Application Serial No. 10/796,886  
Amendment Dated August 24, 2005  
Reply to Office Action Dated May 24, 2005

**Amendments to the Drawings:**

FIG. 1

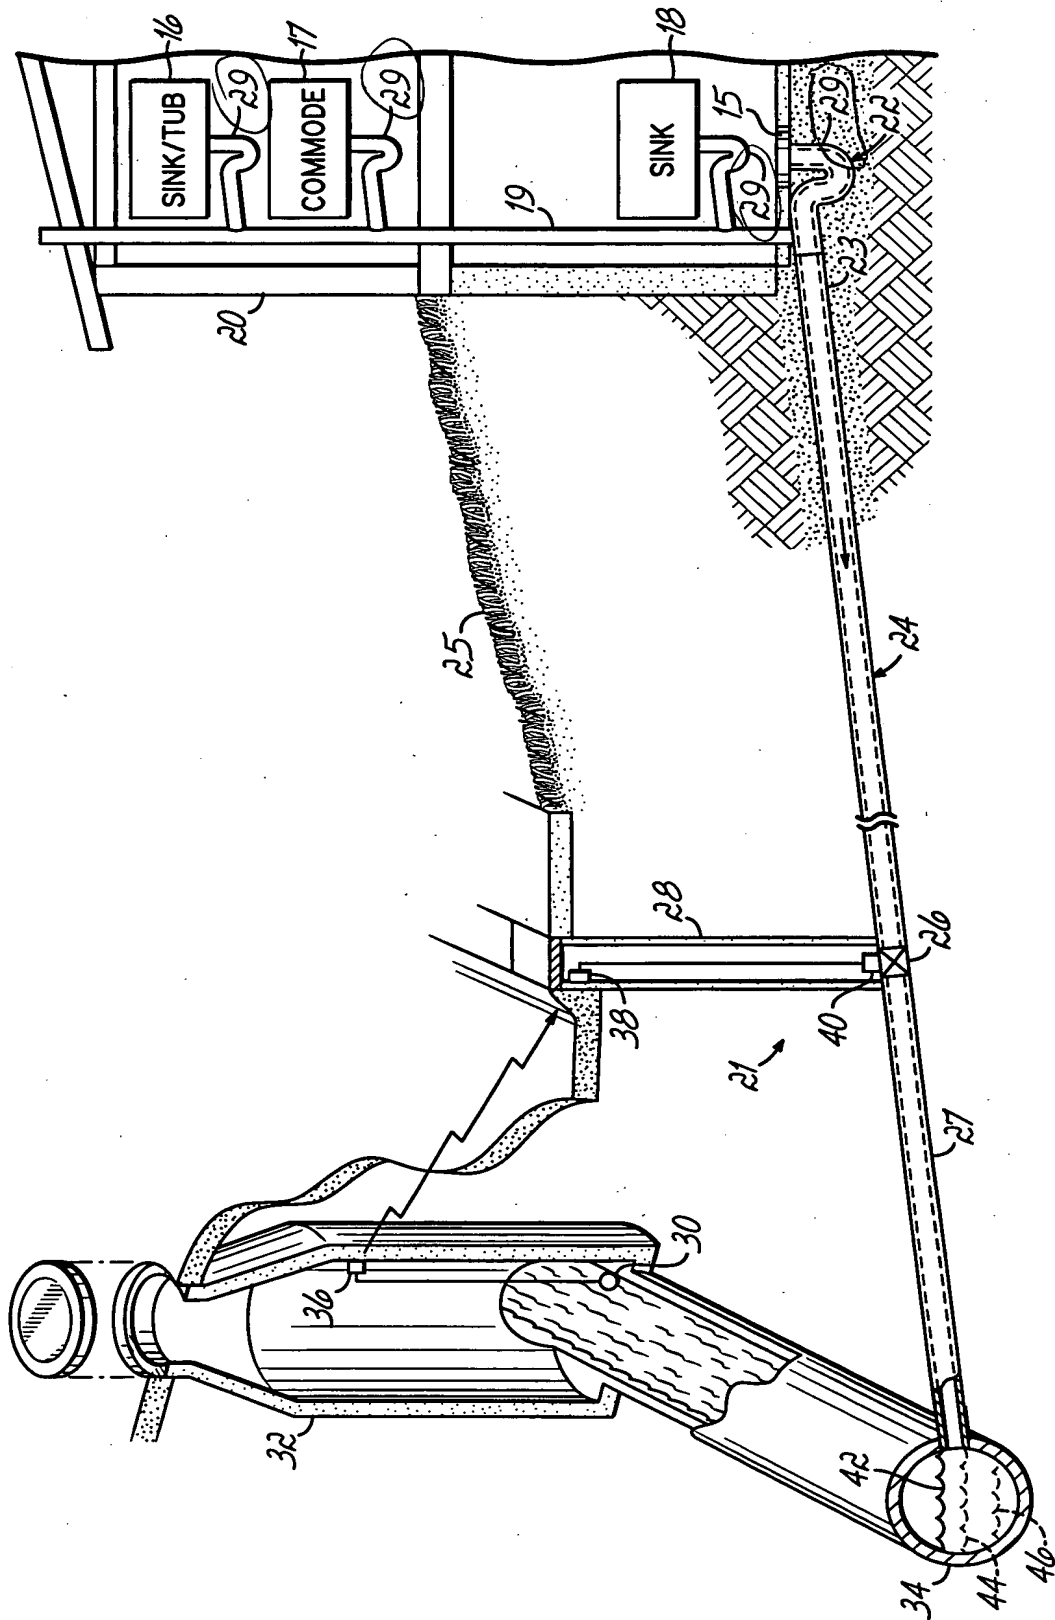
The attached 9 sheets of drawings includes changes to Figs. 1-2 and 4-8B. These sheets, which includes Figs. 1-2 and 4-8B, replaces the originally filed sheets including Figs. 1-2 and 4-8B. All of the Figures, except Fig. 3, are being amended to label a running trap 29 as part of the building drain piping 22.
